# **ESHER GREEN JUNCTION IMPROVEMENT**

# SURREY COUNTY COUNCIL LOCAL COMMITTEE (ELMBRIDGE) 28 MARCH 2006

# **KEY ISSUE:**

4.1 Drawing No.5477/15 Rev C, Appendix 'B', shows the proposed modification to the junction improvement scheme approved by the Committee on 26 September 2005. The proposed traffic island opposite Esher Place Avenue would be altered to allow the right-turn manoeuvres to take place.

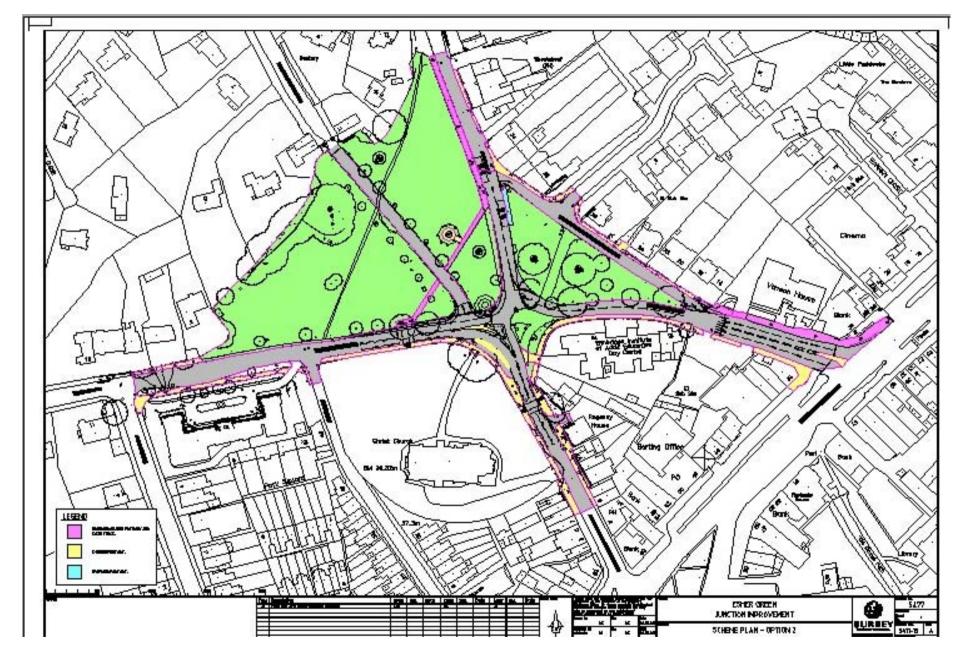
The modification required to the approved scheme in order to retain the right-turn manoeuvres at Esher Place Avenue would be small. Currently, the approved scheme shown in Appendix 'A' proposes a long narrow traffic island in Lammas Lane, opposite Esher Place Avenue, to physically restrict the manoeuvres. By providing a gap in this traffic island the right-turn manoeuvres could be retained without requiring any further modifications to the scheme.

- (ii) Agree that, with reference to (i) above, the Traffic Regulation Order is not progressed.
- (iii) Agree a modification to the scheme approved by this committee on 26 September 2005, whereby the proposed traffic island in Lammas Lane opposite Esher Place Avenue is modified as shown in Appendix 'B' to enable the right-turn manoeuvres to take place.
